NUMBER
DEFK14021

ATTACHMENT A**Coonskin Park Maintenance Facility**

Addendum No.: 4

C-2-4-1 -	Partial Site Utility Plan Notes	- 1 page
C-2-4-2 -	Partial Site Utility Sections	- 1 page

**C-2-4-1**

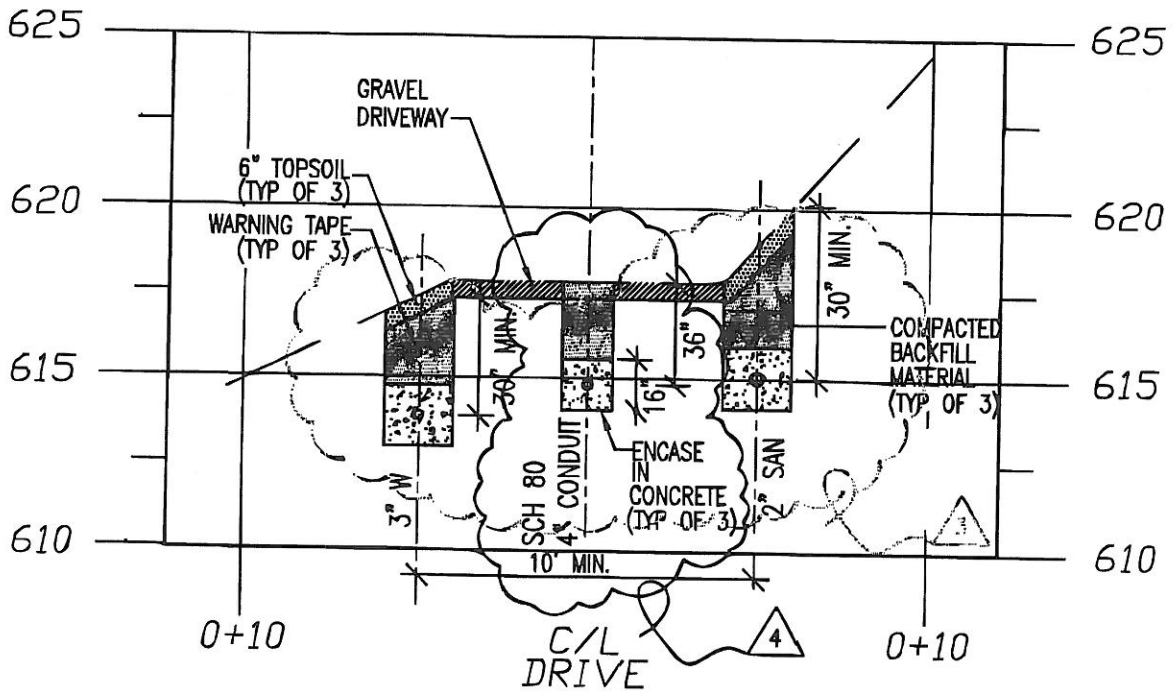
1. REVISION: – **Revise the keyed note 1 as per Attachment C-2-4-1.**
2. ADDITION: – **Add the keyed note 9 as per Attachment C-2-4-1.**
3. REVISION: – **Revise Sections A-A and B-B as per Attachment C-2-4-2.**

1. ALL CONDUITS FOR PRIMARY FEED MUST BE A MINIMUM OF 36" DEEP. CASE SCH 80 PVC CONDUIT UNDER ROAD WAY PER DETAIL B-B, CONDUIT IN OTHER LOCATIONS CAN BE SCH 40 PVC. ALL SECONDARY OR SERVICE FEEDS MUST BE A MINIMUM OF 30" DEEP.
2. CONTRACTOR SHALL PROTECT EXISTING FACILITIES THROUOUT CONSTRUCTION (I.E. SOCCER FIELD, AMPHITHEATER, ETC.).
3. CONTRACTOR SHALL INCLUDE THE COST FEES OF UTILITY CONNECTIONS IN BIDS.
4. SANITARY SEWER SHALL BE A MINIMUM OF 18" BELOW THE ELECTRICAL SERVICE AT ANY CROSSING.

9. GAS LINE SHALL BE PE2406 YELLOW GAS PIPE AT A MINIMUM DEPTH OF 18". CONTRACTOR SHALL FURNISH AND INSTALL PIPE, AND SET METER LOOP PROVIDED BY THE GAS UTILITY COMPANY, LINE TESTING AND FINAL CONNECTION SHALL BE BY GAS UTILITY COMPANY.
